RE: PUTT PUTT DEVELOPMENT

The drainage report submitted for the captioned development is not acceptable since it is not in compliance with the AMAFCA RES. 72-2. The land to the west of this parcel is not presently subjected to uncontrolled developed runoff; in the absence of appropriate drainage facilities for the conveyance of the runoff and of public R.O.W. across that property, the runoff volume and rate from this development cannot be increased. As verbally indicated the construction of an asphalt-lined channel is not an acceptable ultimate solution for the conveyance of the flow from the northeast. It is anticipated that the City will construct a storm sewer line to intercept and convey said runoff in the 30ft drainage easement at the time of development of the property to the west.

DRAINAGE REPORT

PUTT PUTT GOLF COURSE  
ALBUQUERQUE, NEW MEXICO

DRAINAGE R.O.W. CHANNEL SECTION

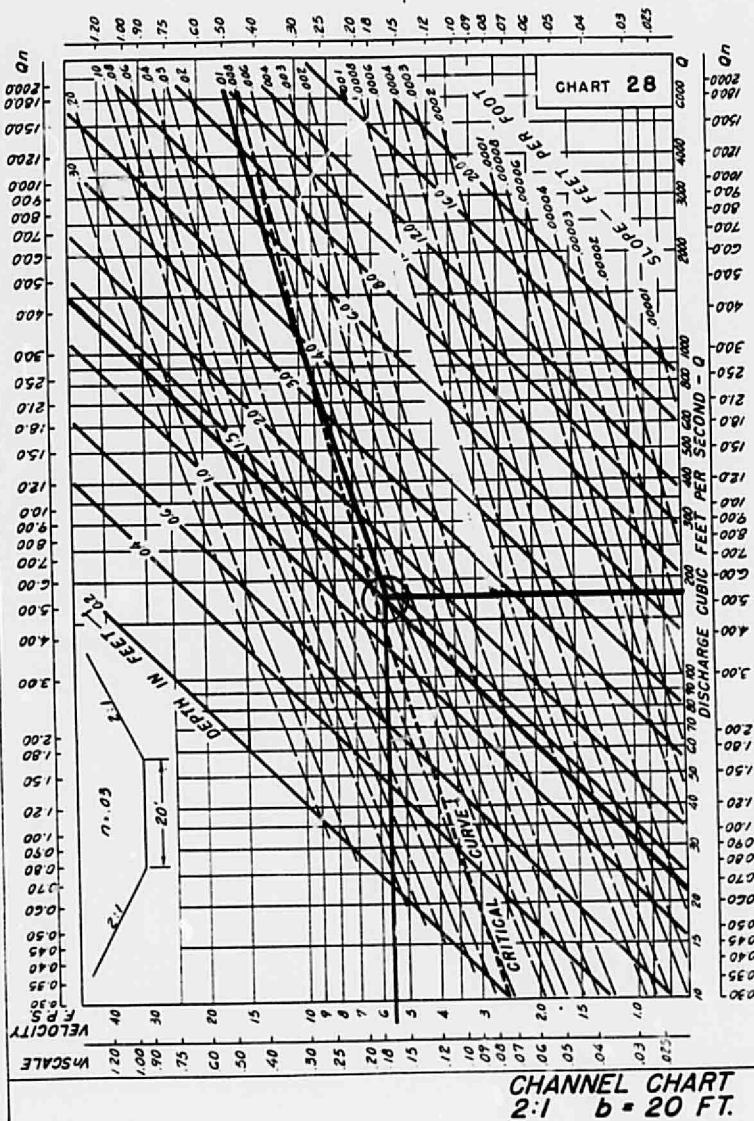
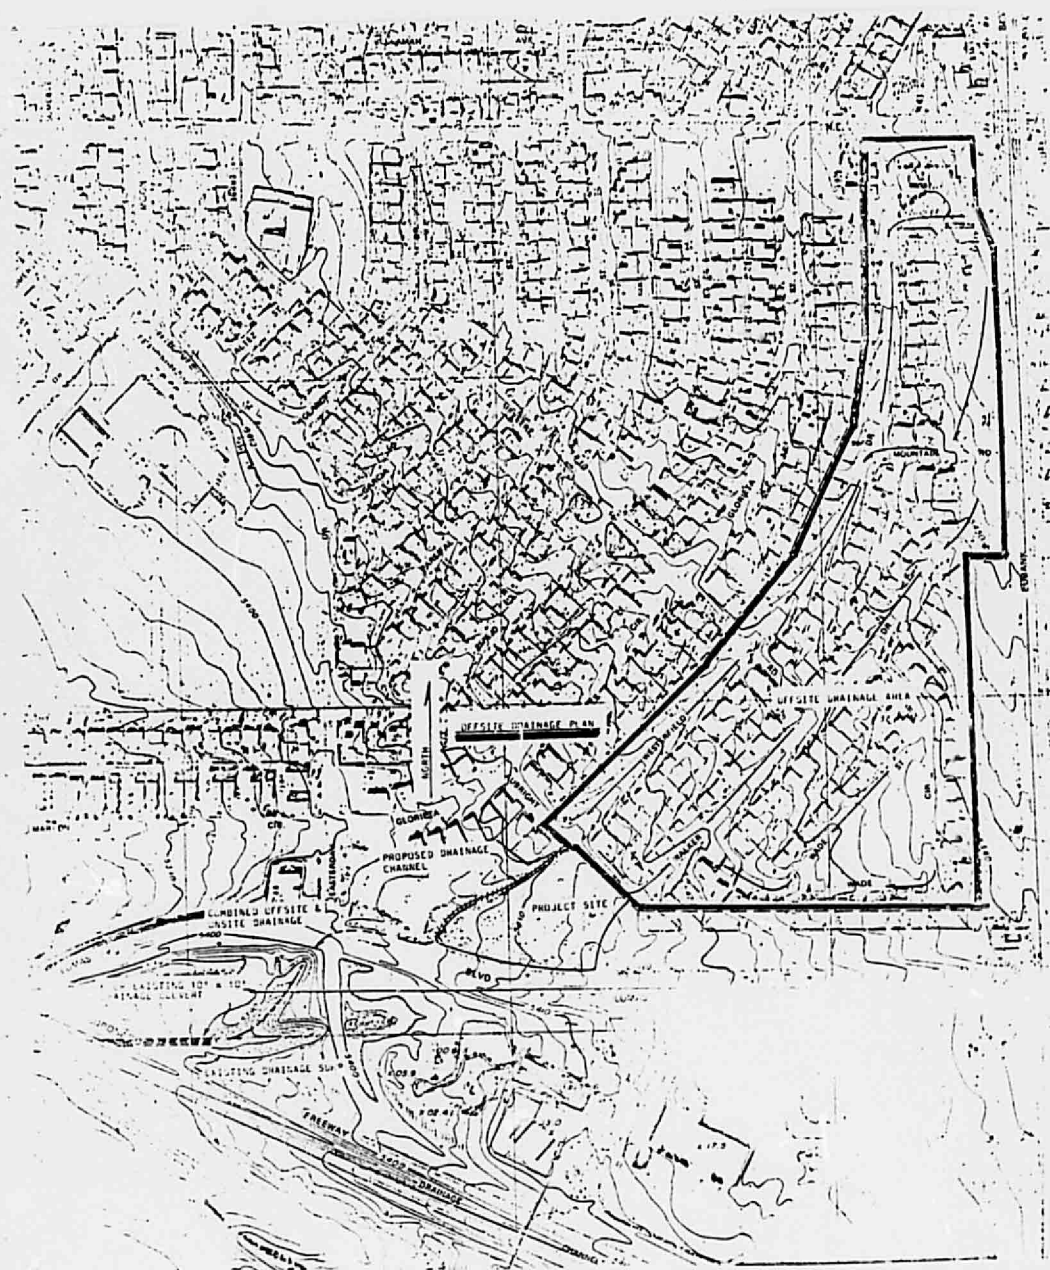
This letter is written to amend previous correspondence in regard to the caption development. The requirement that no increase in run-off will result as a consequence of this development is reiterated. Ponding provisions on site must be made in order to comply with this requirement.

In regard to the construction of the drainage facility, at of the Northwest boundry of the property, within the existing 30 ft. drainage easement, after discussions with Mr. Rip Orr and Mr. John Myers, the conclusion was reached that the development of this project will be granted if the developers construct the asphalt lined channel, indicated in the drainage report, from Aubright Street to the location where the water is currently discharging.

The asphalt channel side has been lowered on the west side as shown on the drainage plan to permit the runoff to flow into the low spot on the undeveloped tract of land to the west before flowing across Lomas Blvd. This maintains the existing runoff pattern.
